Project	IEEE 802.16 Broadband Wireless Access Working Group < http://ieee802.org/16 >	
Title	Framework for Enabling Closed-loop MIMO for OFDMA	
Date Submitted	2004-11-14	
Source(s)	<p>Wonil Roh, JeongTae Oh, Chan-Byoung Chae, Kyunbyoung Ko, Hongsil Jeong, Sung-Ryul Yun, Seungjoo Maeng, Jaeho Jeon, Jaeyeol Kim, Soonyoung Yoon</p> <p>Samsung Electronics Co., Ltd.</p> <p>Young-Ho Jung, Seung Hoon Nam , Jaehak Chung, Yungsoo Kim, Sung-Jin Kim, Hojin Kim</p> <p>Samsung Advanced Institute of Technology</p> <p>Erik Lindskog, Harold Artes, Djordje Tujkovic, Kamlesh Rath, Andreas Bergkvist, V. Shashidhar, B. Sundar Rajan, Rahul Vaze, Bob Lorenz, Babu Mandava, A. Paulraj, Aditya Agrawal</p> <p>Beceem Communications, Inc.</p> <p>Wen Tong, Peiyong Zhu, Ming Jia, Dongsheng Yu, Hua Xu, Jianglei Ma ,Mo-Han Fong, Hang Zhang, Brian Johnson</p> <p>Nortel Networks</p> <p>Qinghua Li, Xintian Eddie Lin, Shilpa Talwar, Randall Schwartz, Sumeet Sandhu, Nageen Himayat</p> <p>Intel Corporation</p> <p>Bin-Chul Ihm, Yongseok Jin, Jinyoung Chun, Kyuhyuk Chung</p> <p>LG Electronics</p> <p>Kevin Baum, Mark Cudak, Tim Thomas, Fred Vook Xiangyang (Jeff) Zhuang</p> <p>Motorola Labs</p> <p>Jianzhong (Charlie) Zhang

Figure 231c - Mapping of MIMO coefficients for quantized precoding weight for enhanced fast MIMO feedback payload bits

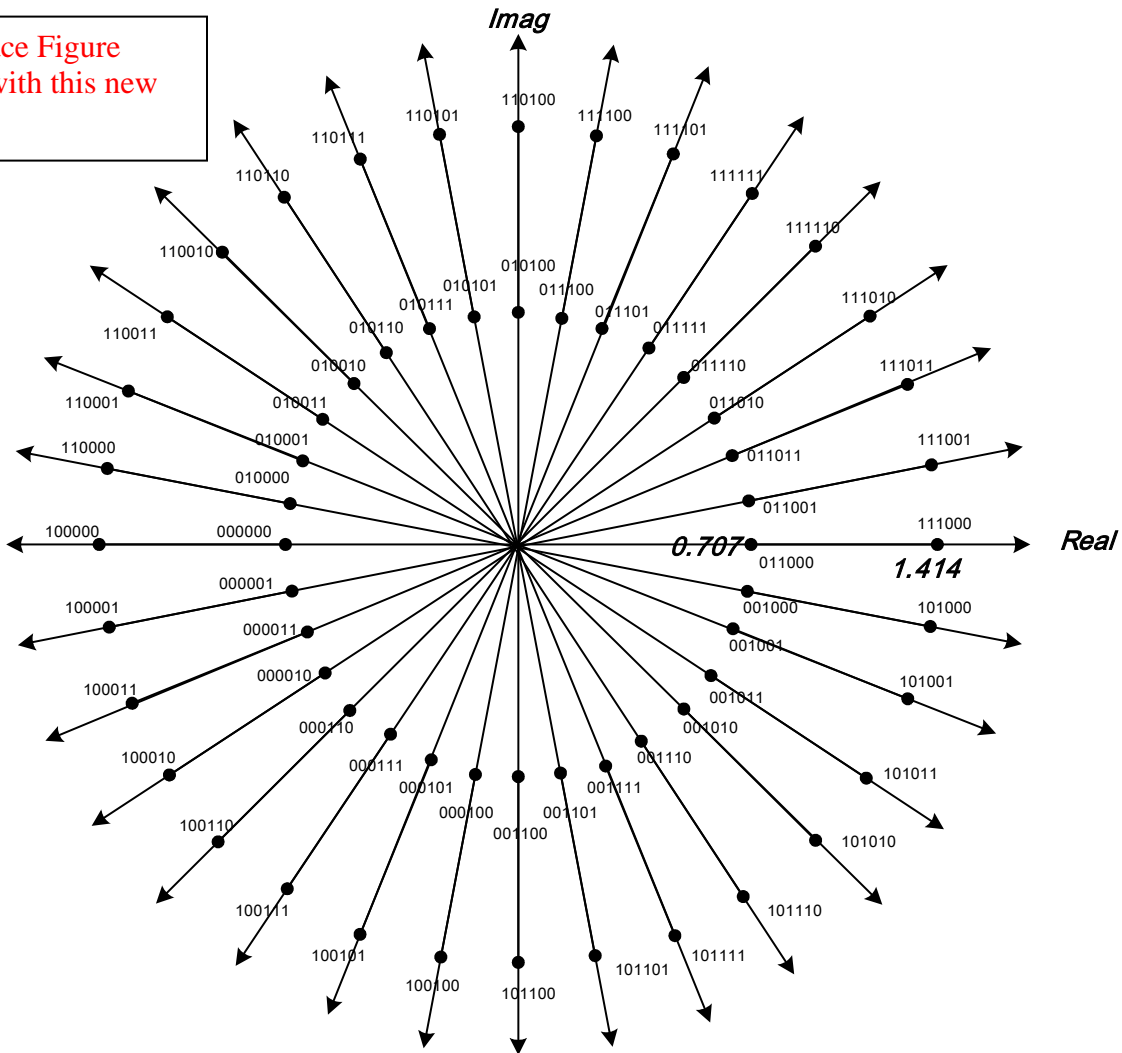
8.4.5.4.10.6 Fast MIMO Feedback of Quantized Precoding Weight for Enhanced FAST_FEEDBACK Channel

When the FAST_FEEDBACK subheader Feedback Type field is '01' or '10', or the CQI Feedback Type field in the MIMO Compact DL-MAP IE() (see 6.3.2.3.43.6.7) is 001, or the CQI Feedback Type field in CQICH_Enhanced_Alloc_IE() (see 8.4.5.4.1512.1) is 001, the MSS shall report the MIMO coefficient the BS should use for best DL reception (see 8.4.8.1.6). The mapping for the complex weights is shown in Figure 231c, and the SS shall construct the 6 CQI bits with 0 as the MSB and the mapped code as the remaining LSBs. For this type of feedback, if N is the number of BS transmit antennas, then $(N-1)$ CQICH shall be allocated to the SS and SS shall report the desired antenna weights of antenna 1 through $N-1$ based on antenna 0.

[Replace Figure 231c with this new figure]

Figure 1 H-ARQ Enabled Vertically Encoded 2x2 MIMO System

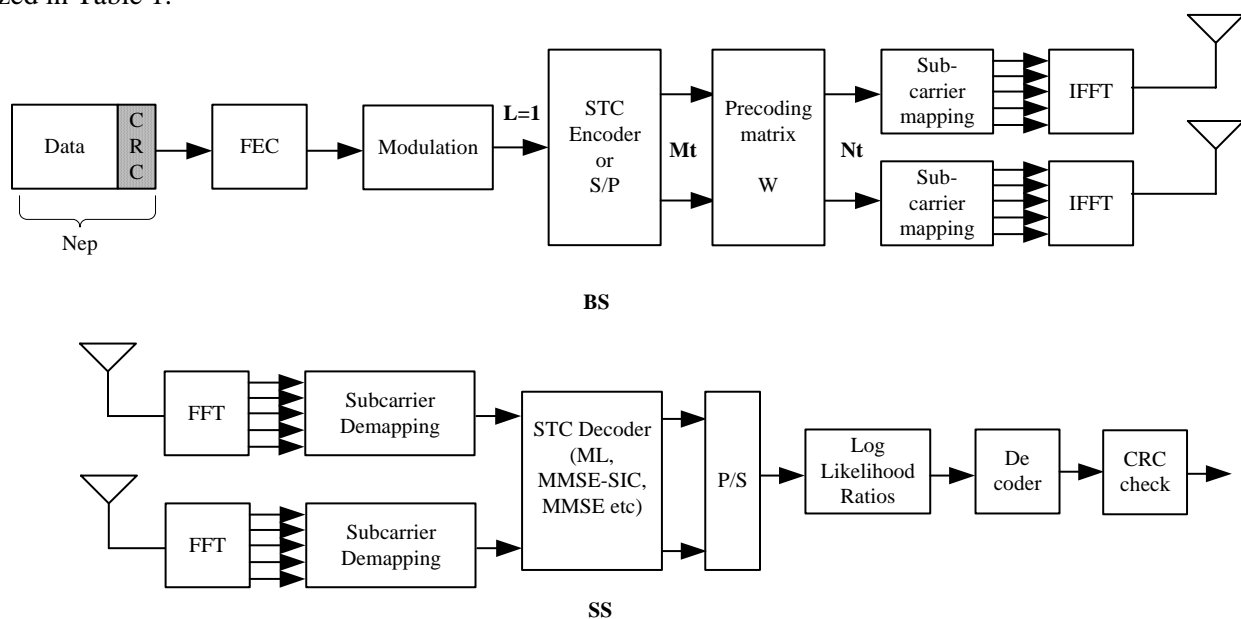
Some clarification is made on burst mapping for H-ARQ when multiple MIMO layers are transmitted on the same physical resource. The multiple layer transmission is enabled when spatial multiplexing (SM) schemes are employed with multiple modulation and coding blocks implemented for each spatial layer. We call it horizontal encoding (HE) and this mode enables adaptive rate control for each spatial layer. The other class of spatial multiplexing schemes is called vertical encoding (VE) and it features a common modulation and coding block. Transmit diversity (TD) can be also regarded as single layer technique. Figure 1 shows an example of 2x2 VE MIMO system, whereas Figure 2 illustrates that of 2x2 HE MIMO system. In both figures, L equals the number of layers, Mt the number of STC output streams, Nt the number of BS transmit antennas, and W denotes the precoding matrix. Their relations according to the current standard are tabularized in Table 1.

In both Figure 1 and Figure 2, when there is no precoding matrix at Tx, Mt becomes the number of transmit antennas. In Table 1, the existing open-loop matrices (A, B, or C) are noted and the superscript ¹ indicates the applicability of the antenna grouping technique.
